ATOS Safety Notice

All models with carbon control frame and no nose wires

5 May 2004

Picture 1 / Nose connection wire

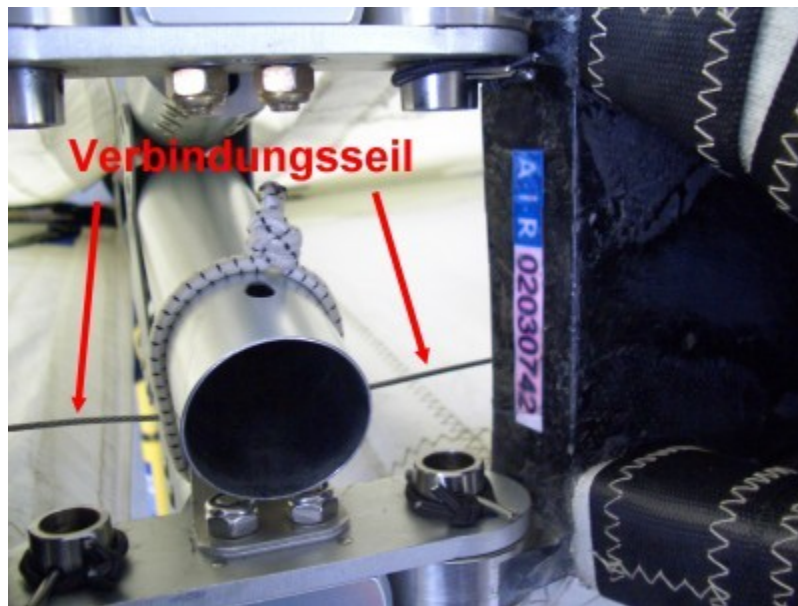
During bi-annual safety inspections at A-I-R, some gliders were found to have damaged circulation cables as shown in Picture 1

This cable is easiest to inspect during set up before the glider is fully rigged. As a precaution the cable must be checked (optically) for kinks and broken strands. Alternatively it can be checked by feeling along the cable with a finger-nail. Note: The cable must not be removed for the check. (Picture 2 shows a damaged cable which must

Picture 2 / damaged cable

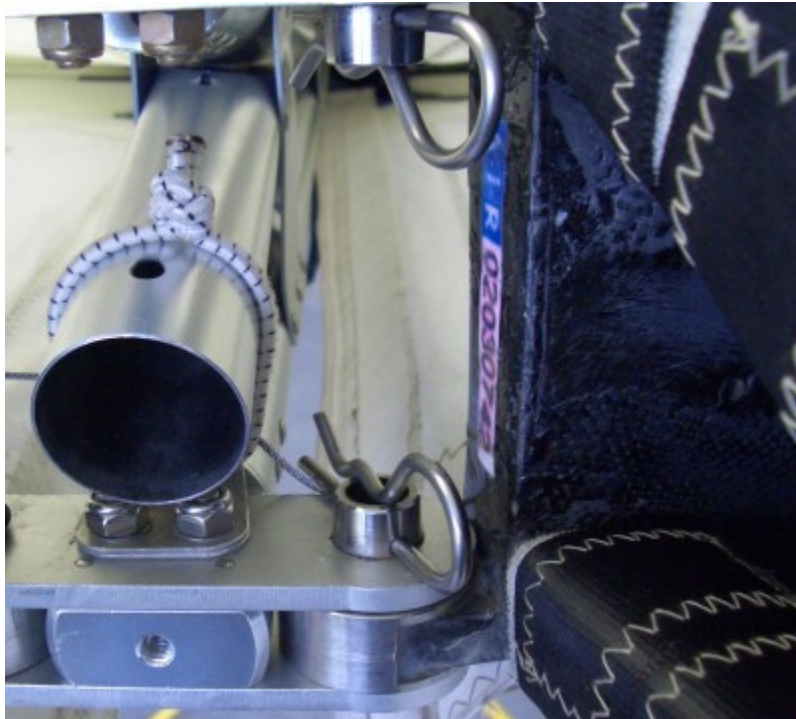
be changed.)

Important: This is important and must be done before your next flight! Do not fly with one or more broken strands. (There may be further hidden damage.) The cable must be changed.

Picture 3/ Miss-routing of the cable.

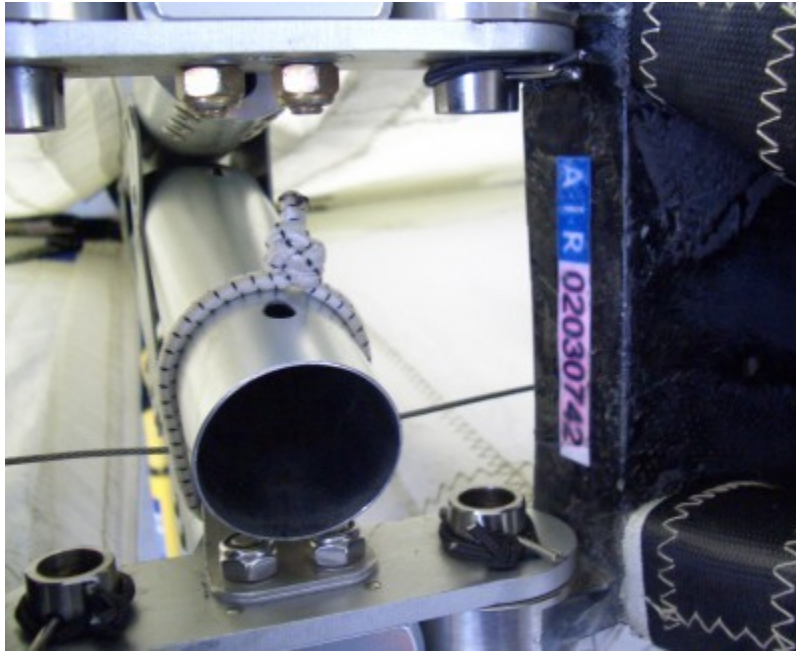
The cable can be damaged if miss-routed as is shown in **Picture 3**. This does cause symptoms of an unusually high cable tension when connecting the side wires and noisy movement of the A frame.

Note: Miss-routing of the cable can only occur during rigging. It cannot occur if the glider is rigged correctly.

Take care: Do a pre-flight check as described in the manual. The whole length of the control cable should be checked

Picture 6 / Wire rope protection modification.

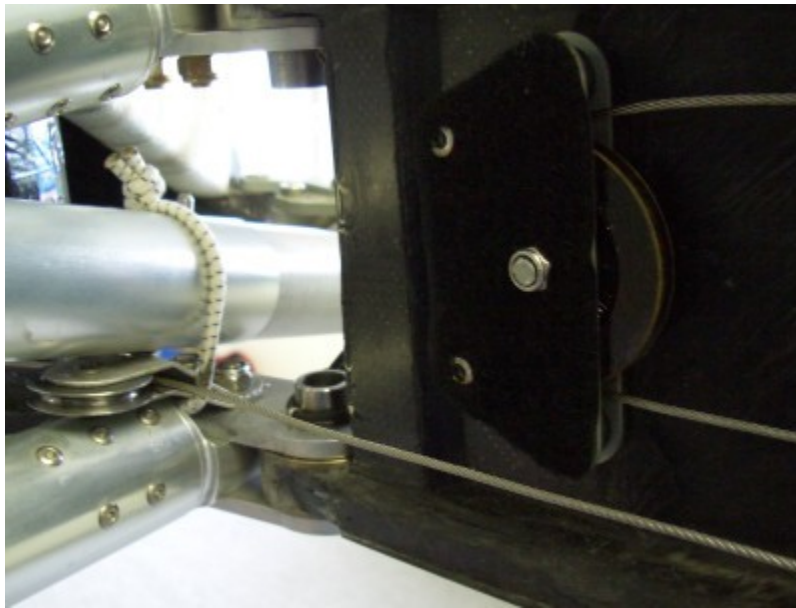
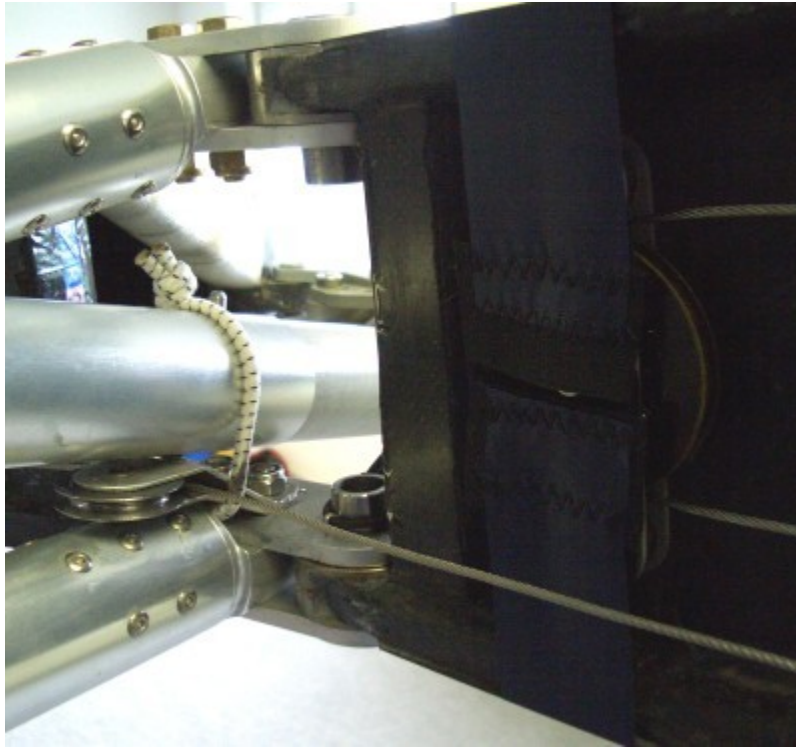
A modification has been made to avoid damage to the cable in the way described above for all new production gliders. However pre-flight checks should still be carried out.

The modification consists of:

- 4 Replacement pins for the main bolts.
- 2 rope protection webbings which attach with Velcro around the D-spar.
